ADDENDUM NO. 1

**RESTROOMS & LAUNDRY RENOVATION
KEYW WEST HISTORIC SEAPORT
ITB #17-007**

ADDENDUM NO. 2

RESTROOMS & LAUNDRY RENOVATION KEYW WEST HISTORIC SEAPORT ITB #17-007

PLUMBING FLOOR PLAN – BUILDING 'A'

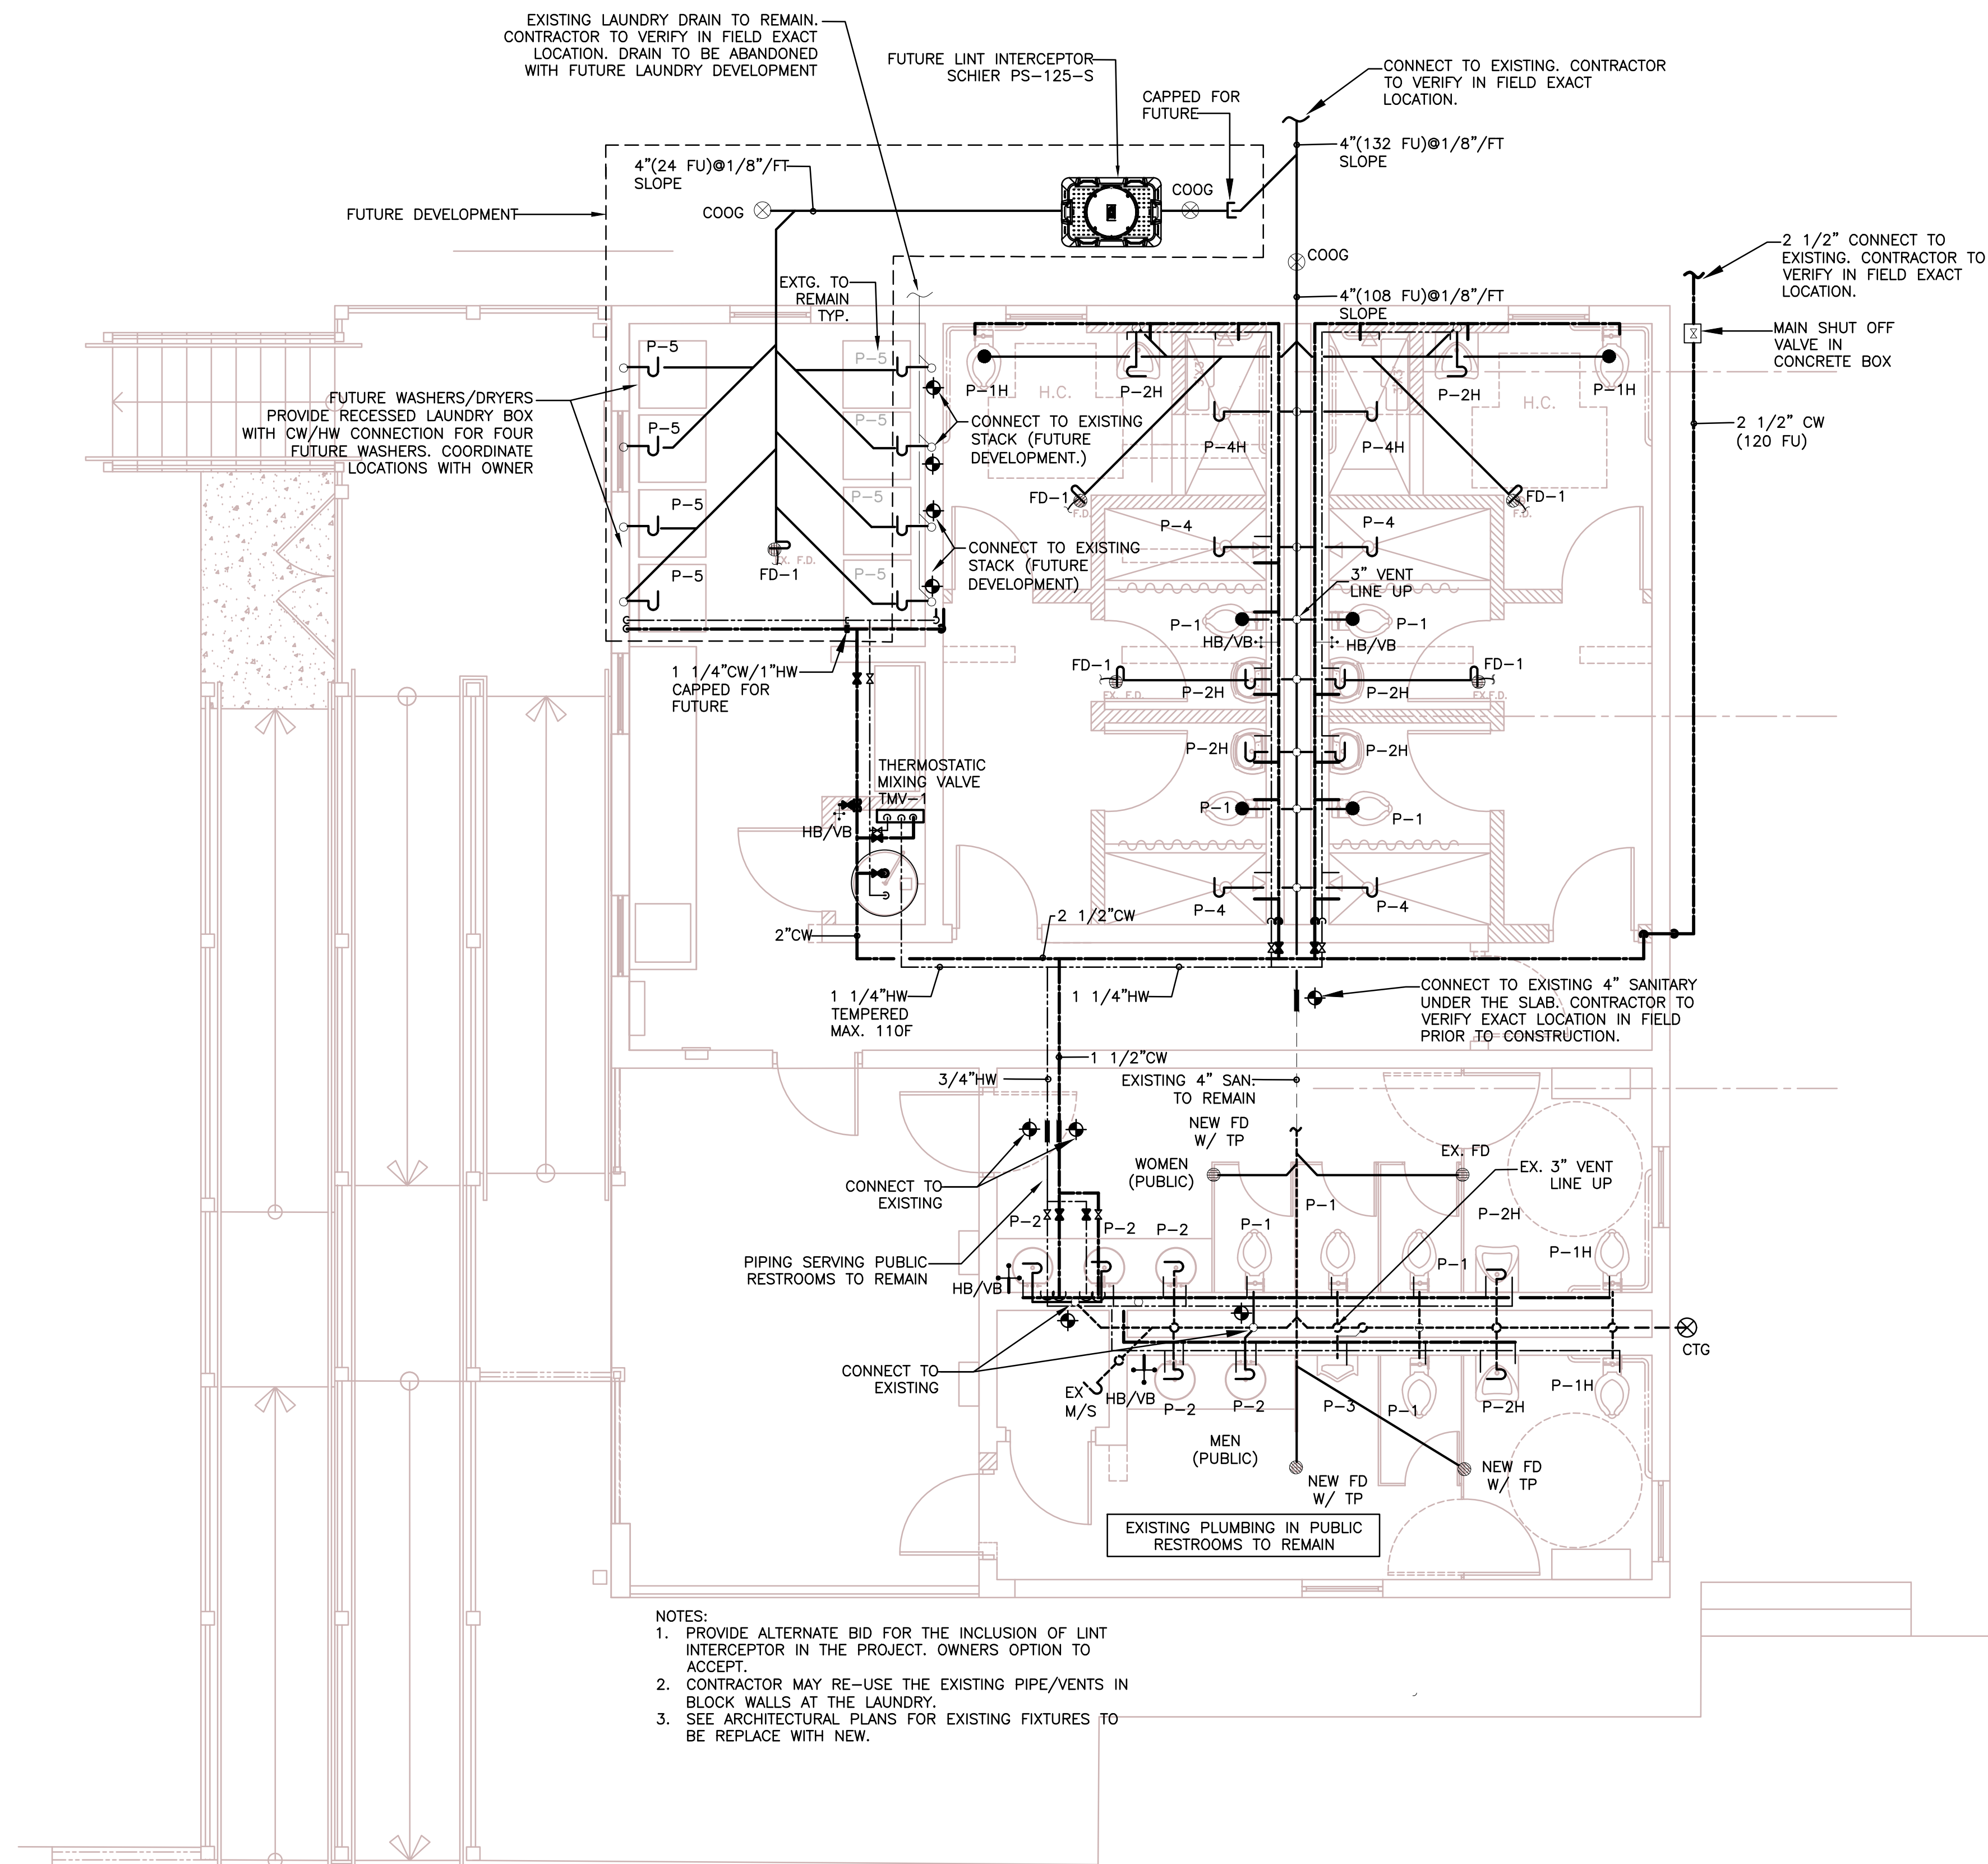
9. The scope of work indicates laundry equipment is to be provided for Building A. Division 11 does not specify the equipment but tells us to coordinate with the equipment supplier for hookup information. There are no mechanical drawings but the electric and plumbing drawings indicate future Laundry equipment. Are we to reuse existing or include new washers and dryers in this proposal?

The existing laundry equipment will be reused. Part of the scope of work for this area is to provide the electrical upgrades, hot/cold water hook-ups, drainage, and vent requirements for (8) future stack washer/ dryer units. Sheet P-2 calls for (4) recessed laundry boxes to be installed. This note on P-2 should reflect (8) recessed laundry boxes with associated wiring, piping and duct to be installed.
